Subject: **WATR 2007o – Bunche Park Water Main Replacement Project**
Notice of Change of Conditions

**RE: Notice of Change of Conditions
City of North Miami Beach – Bunche Park Water Main Replacement Project
Project No. 24-016-SG**

We have now quantified the change of conditions to include 6 different changes quantified below.

TYPICAL PAVEMENT RESTORATION

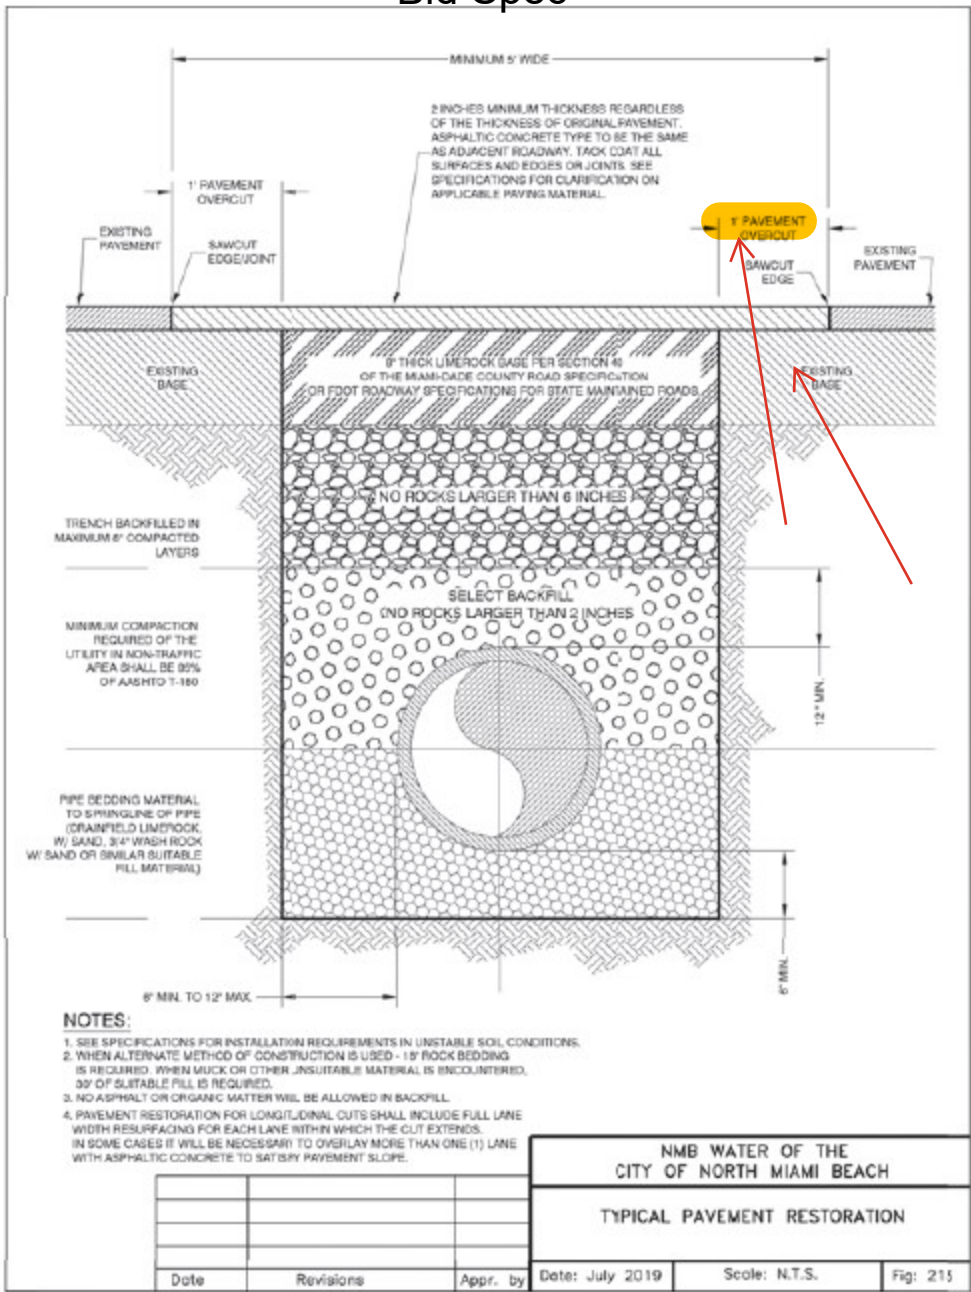
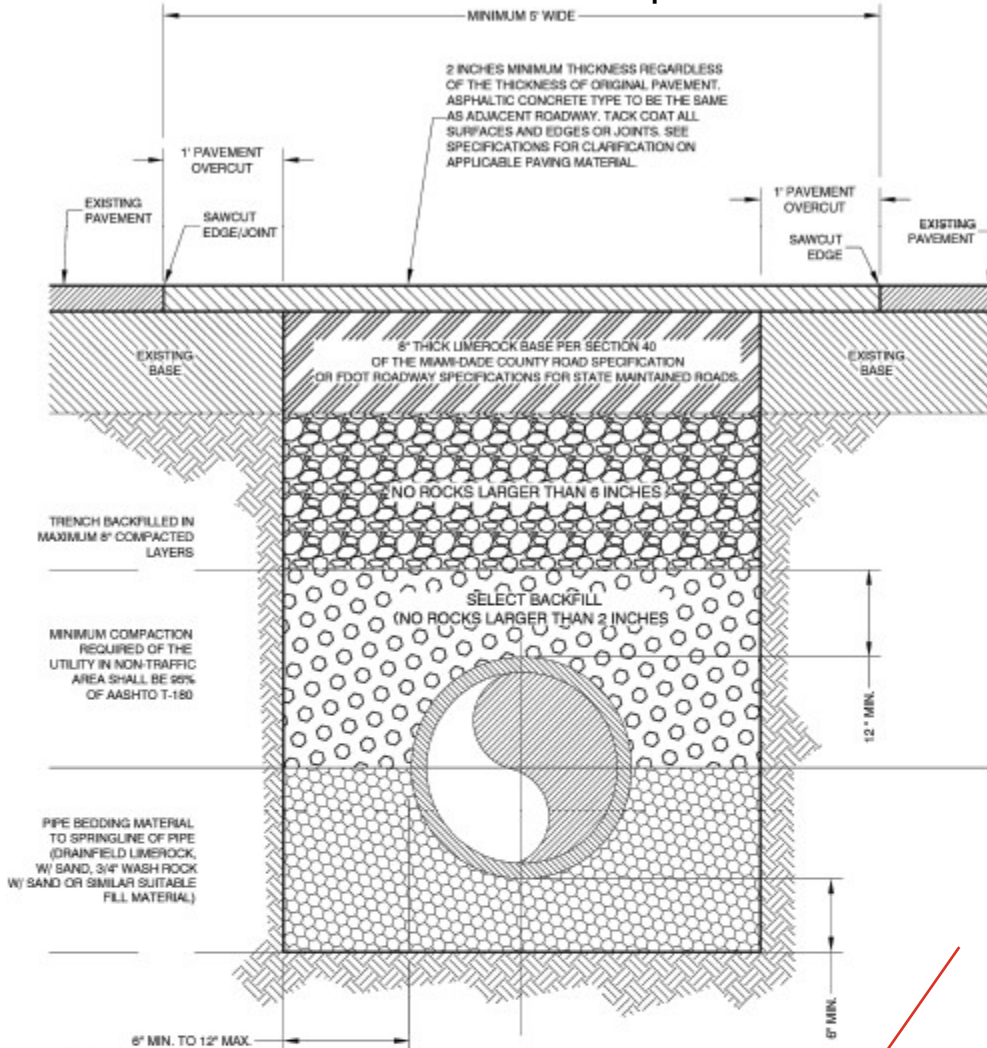
- Change of conditions item #5 includes the additional 1' of asphalt restoration width from the bid spec of trench width plus 1' on both sides of the trench to Miami Gardens spec of trench width plus 1.5' on both sides of the trench. Miami Gardens' restoration detail also calls for the installation of 12" of limerock on 1.5' on both sides of the trench where the bid spec called for no limerock past the trench width. This cost is \$48,915.77
- Change of conditions item #6 is the increased bond cost for all of these items which is 2.5% the value of the change at \$187,943.13, which is \$4698.58.

AW 05 - Additional width on the trench restoration

Limerock Calculations						
Length (Ft)	Width (Ft) 1.5' each side of trench	Depth (In)	CuFt	Compaction Factor (1.75)	Tons	\$/Ton (\$30)
4261	3	12	12783	22370.25	828.5277778	\$24,855.83

Asphalt Calculations						
Length (Ft)	Width (Ft)	Depth (In)	CuFt	CY	Tons	\$/Ton (\$95)
4261	6	2	4261	157.8148148	319.575	\$30,359.63
4261	7	2	4971.166667	184.117284	372.8375	\$35,419.56

Bid Spec

Miami Gardens Spec

FOR MIAMI GARDENS RIGHT OF WAY, 12" LIMEROCK BASE IN (2) 6" LIFTS (EACH LIFT COMPACTED TO 98% OF MAX. DENSITY) WIDTH OF LIMEROCK BASE TO BE "TRENCH WIDTH PLUS 1.5FEET ON EACH SIDE MATCH EXISTING ASPHALT (1.5' MIN.); DENSITY/COMPACTION TESTS WILL BE REQUIRED FOR BACKFILLING LIFTS, SUBGRADE AND LIMEROCK LIFTS.

After careful review, we find the proposed changes and associated costs acceptable, given that these revisions were introduced post-bid and were not reflected in the original bid documents. The approved items and costs are as follows:
